To: Abrika Properties, LLC – Brandon Cohen and Scott Schlosser  
Alpine Engineering – Gary Brooks  
Pyman and Associates – Rick Pylman

Re: Haymeadow Subdivision Filing 1 – Staff and Referral Agency Comments – First Review

### *DRAFT Final Plat Document:*

**FINAL PLAT**  
**BRUSH CREEK MEADOWS FILING 3**  
 LOCATED IN TRACTS 38, 44, AND 55,  
 SECTION 4, TOWNSHIP 5 SOUTH, RANGE 84 WEST OF THE SIXTH P.M.  
 TOWN OF EAGLE, COUNTY OF EAGLE, STATE OF COLORADO

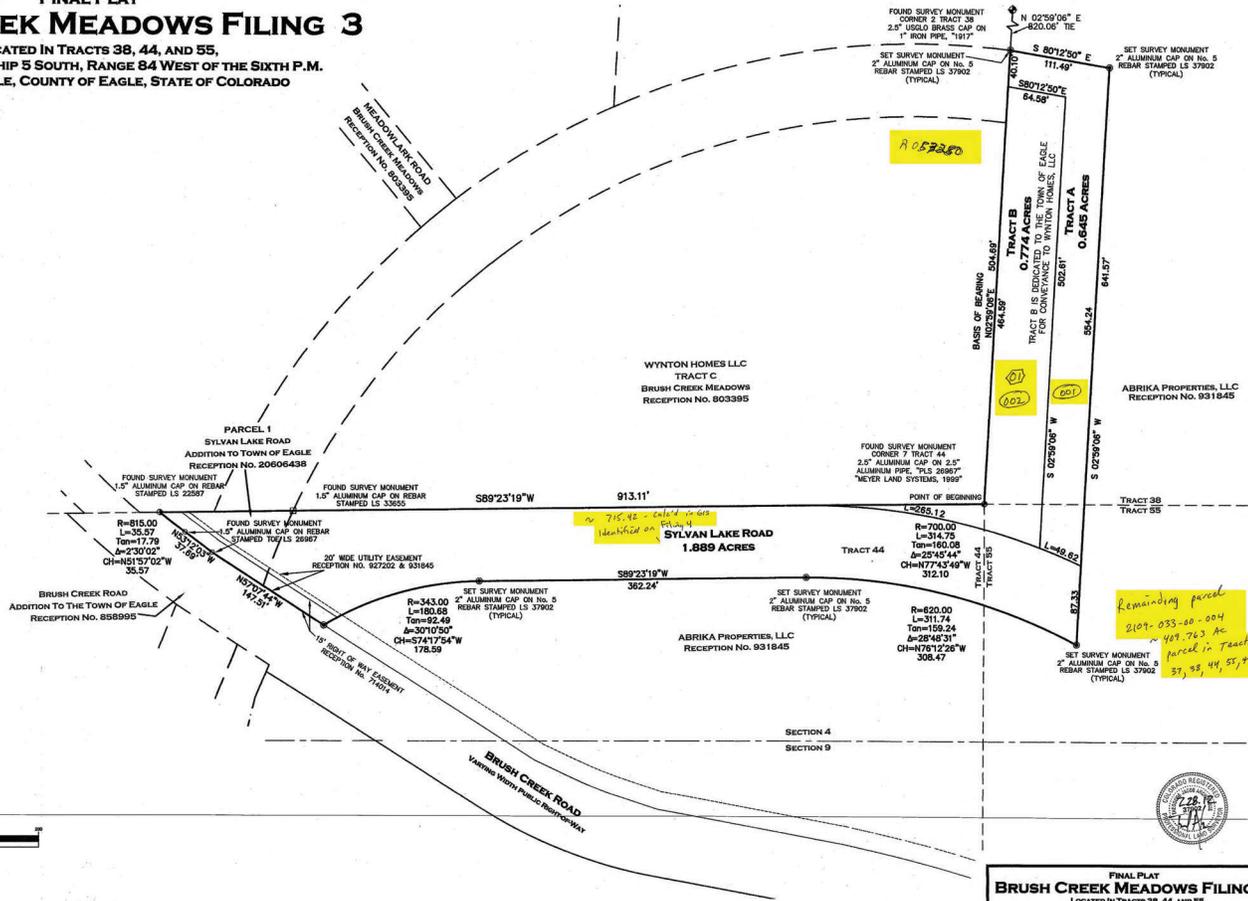
- 4) The legal description under the Certificate of Dedication and Ownership includes Sylvan Lake Rd. Public ROW, that was dedicated on the Final Plat of Brush Creek Meadows Filing 3, Reception# 201211315 (attached). Need to also except ROW and change total acreage to 657.343 acres (less 1.889 for the ROW).
